PROJECT: TVFCU
PROJECT NO. 23-018

ADDENDUM NUMBER ONE

This Addendum Number one dated Friday, November 7th is hereby appended to and became a part of the Contract Documents for the Trona Valley Federal Credit Union, 1700 Gateway BLVD, Rock Springs Wyoming. Drawings and specifications dated September 27th, 2025.

SHEET NUMBER
1.34

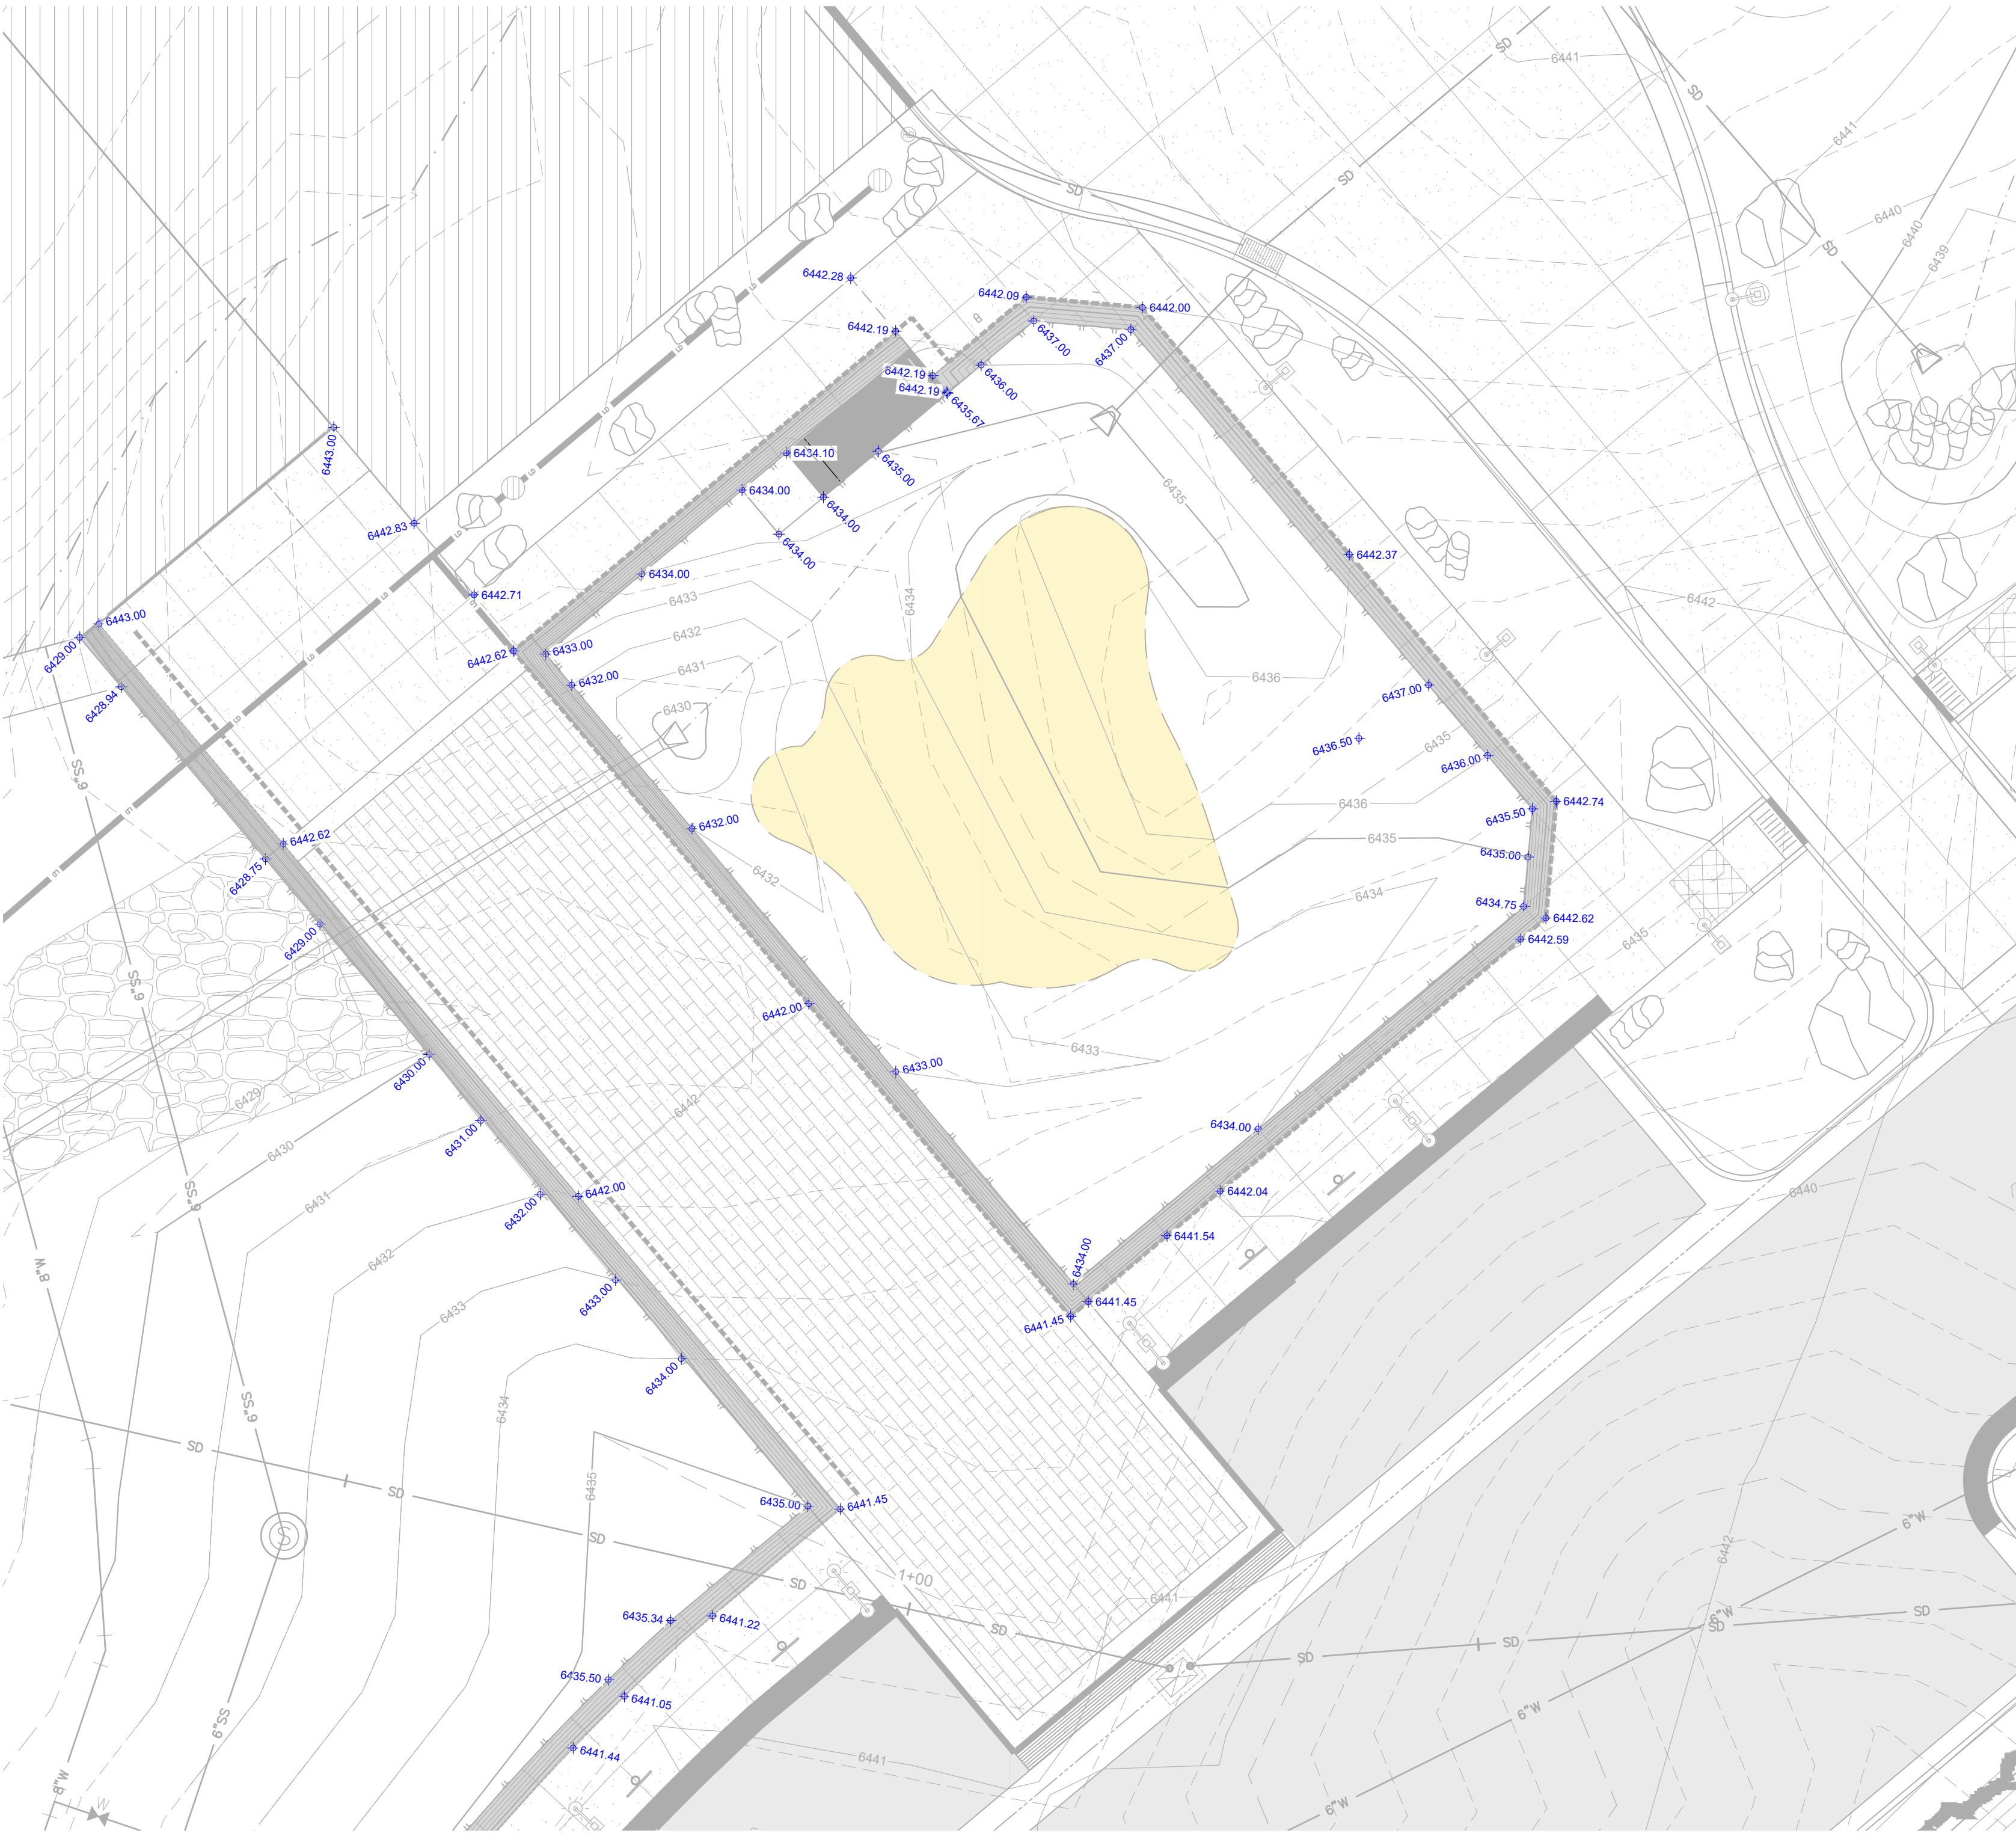
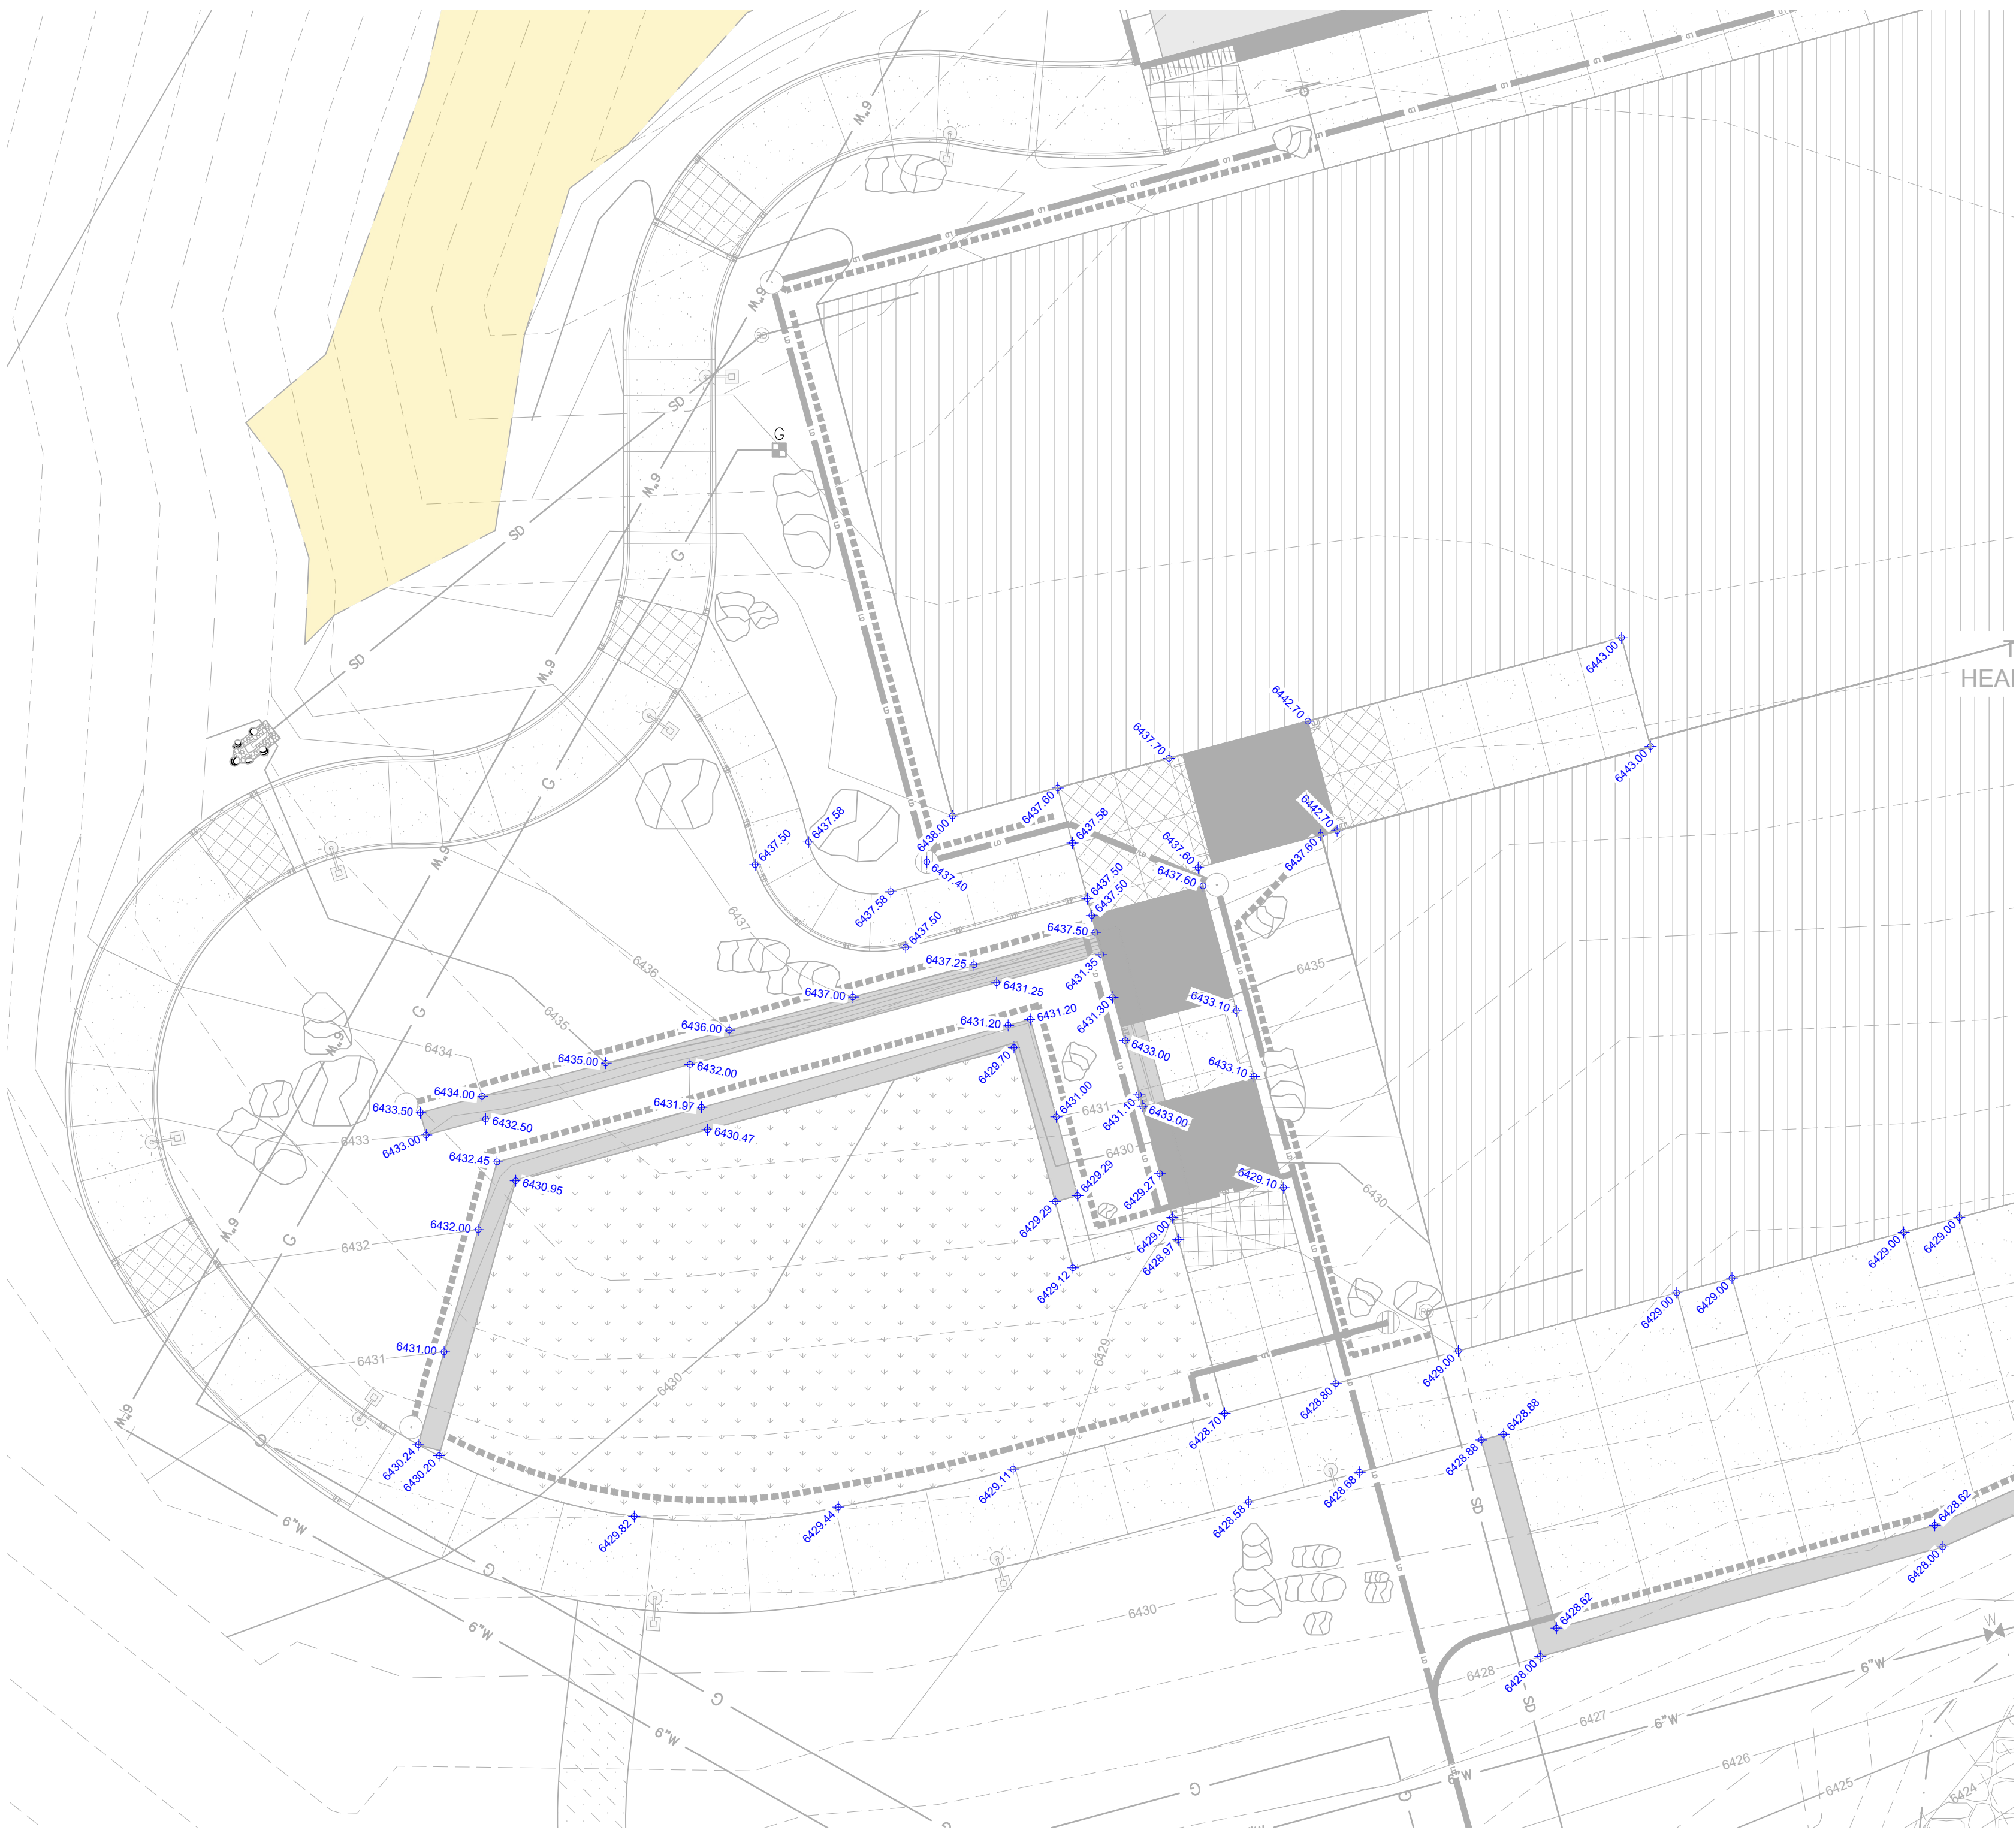
Sheet 1.34:

ADD: See attached sheet for finished surface grades at all retaining wall locations

ALL SPOT ELEVATIONS AT RETAINING WALL LOCATIONS REPRESENT FINISHED GRADE AT THE WALL. THE ELEVATIONS DO NOT REPRESENT THE TOP OF THE WALL BLOCKS. CONTRACTOR SHALL REFER TO THE LANDSCAPE ARCHITECT'S WALL SECTION DETAILS FOR ADDITIONAL INFORMATION.

IT IS THE CONTRACTOR'S RESPONSIBILITY TO CALCULATE WHERE WALL HEIGHTS WILL CHANGE BY ONE BLOCK INCREMENTS VERTICALLY.
